PUBLIC HEARING MEMORANDUM

SUBJECT: **Petition #129-17**, for a SPECIAL PERMIT/SITE PLAN APPROVAL to allow the required lot area to be reduced by 4%, at **19-21 Beaconwood Road**, Ward 6, Newton Highlands, on land known as SBL 54, 22, 44 and 54, 22, 47 containing approximately 9,602 sf of land in a district zoned MULTI RESIDENCE 1. Ref: Sec. §7.8.4.D.4, §7.8.4.D.5, and §7.8.4, of Chapter 30 of the City of Newton Rev Zoning Ord, 2015.

Re: Special Permit – 19 -21 Beaconwood Road

19-21 Beaconwood Road
Newton, MA

C. Site Design

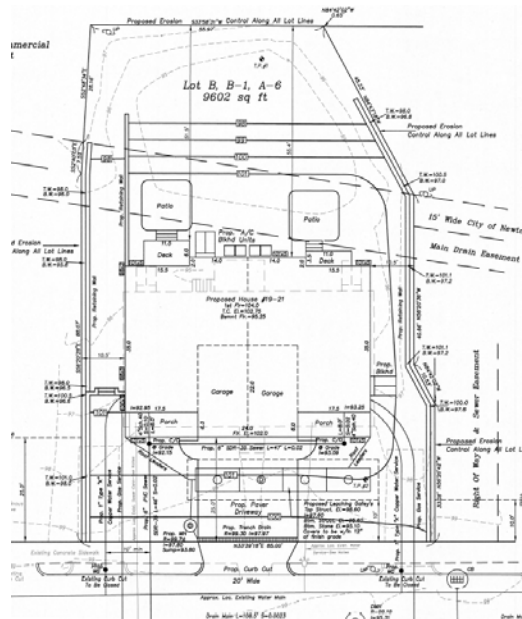
The petitioner is not proposing major changes to the existing site. The two existing curb cuts will be removed and a new 20-foot wide curb cut will be located in the center of the lot. The petitioner is proposing to construct 105 and 95 foot long retaining walls within the setback distances along the right and left boundaries, respectively. These walls vary in height, but do not meet or exceed four feet. Their presence will allow for the creation of patio space at the rear of the structure.

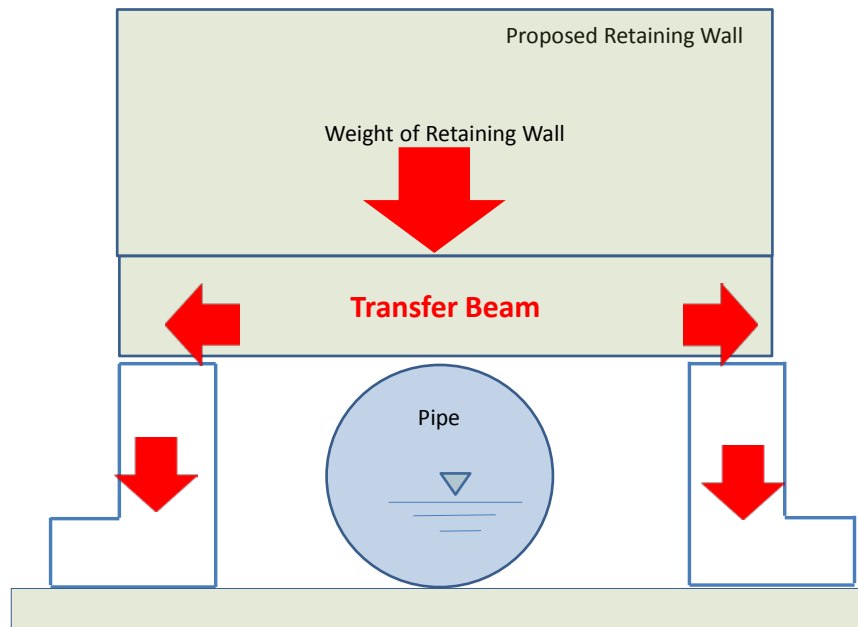
This application entails the demolition of an existing two family dwelling and the construction of a new two family unit on a 9,602 square foot (0.22 acre) lot. The site has 85 feet of frontage on Beaconwood Road along the southeast, commercial property to the northeast & west, and residential units along the south. The site is traversed by a City Utility Drainage Easement that runs [east to west] along the back yard of the lot. Should this permit be approved, the property owner shall obtain a License Agreement with the Law Department for the retaining walls and patios that are proposed over this easement.

Furthermore, if approved; prior to a Building Permit the applicant/contractor of record shall arrange for a Closed Circuit Television (CCTV) Inspection of the drain pipe prior

to construction and post construction prior to applying for a Certificate of Occupancy for either unit.

The site's topography has a high point at elevation 99-feet towards the front, and slopes to the rear at a low point within a depressed area at an elevation just below 95-feet. The engineer of record is proposing to construct retaining walls near the side property lines which would allow the site to be filled and flattened for use as a patio area. A concern of this is that the load carrying capacity of the drain pipe needs to be determined due to added weight of the retaining walls and added soil. At a minimum a registered geotechnical engineer shall submit a certified report that determines the capacity of said drain pipe, with the added loads. At a minimum the footings of the proposed retaining walls shall be "bridged" so that the weight of the proposed retaining walls do not bear down onto the drain pipe but rather distribute the load beyond the pipe limits, see sketch below.

The proposed retaining walls do not appear to act as "dams" since the property on either side of this lot slopes away from the respective common property lines.
